Access Compliance Report

Public Rights-of-Way

(Curb Ramps)

Intersection ID: 50579	Main Street: GREAT_LAUREL_RD	Cross Street: PAPER_TREE_RD	Location: E
ADA ID: 5D0EFB0ECD8	Ramp Type: Perp	Initial Pass/Fail: Fail	Overall Compliance: No
Severity Score: 22.5			
Codes/Mitigation Info/Possible Solution		Field Measurements/Component Compliance

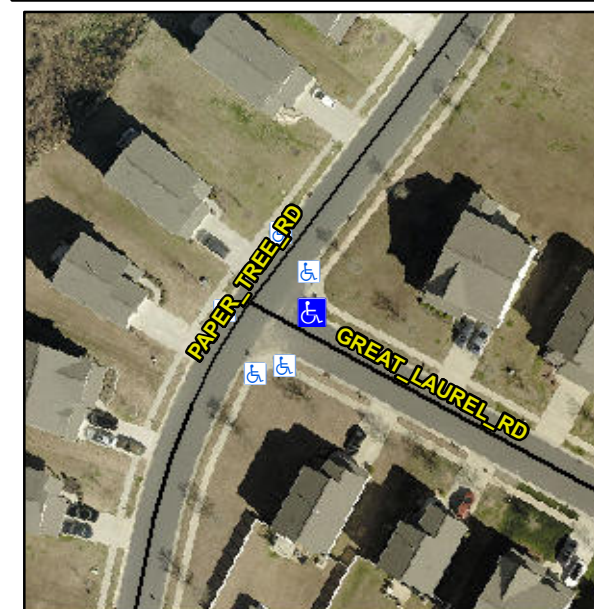
R304.5.1, R304.2.2, R304.5.3

Compliance	Description	Data	Compliance	Description	Data
N/A	Ramp Length (in)	49.0	No	Ramp Slope (%)	9.0
No	Ramp Width (in)	47.5	No	Ramp XSlope (%)	4.5
N/A	Flare Type LT	N/A	N/A	Flare Type RT	N/A
N/A	Flare Slope LT (%)	N/A	N/A	Flare Slope RT (%)	N/A
N/A	Flare Traversable LT?	N/A	N/A	Flare Traversable RT?	N/A
N/A	Landing Length (in)	N/A	N/A	DWS Provided?	N/A
N/A	Landing Width (in)	N/A	N/A	DWS Contrast?	N/A
N/A	Landing Slope (%)	N/A	N/A	DWS Length (in)	N/A
N/A	Landing X Slope (%)	N/A	N/A	DWS Full Width?	N/A
N/A	Landing Curb? (Y/N)	N/A	N/A	DWS Offset (in)	N/A
N/A	Shared Landing?	N/A			
N/A	Gutter Ponding?	N/A	N/A	Gutter Slope (%)	N/A
N/A	Gutter Lip Ht (in)	N/A	N/A	Gutter X Slope (%)	N/A
N/A	Painted X Walk1?	No	N/A	Painted X Walk2?	N/A
	X Walk 1 Direction	To S		X Walk 2 Direction	N/A
N/A	X Walk 1 Width (in)	N/A	N/A	X Walk 2 Width (in)	N/A
	X Walk 1 Slope (%)	1.8		X Walk 2 Slope (%)	N/A
	X Walk 1 X Slope (%)	2.0		X Walk 2 X Slope (%)	N/A

Remove & Replace Entire Ramp.
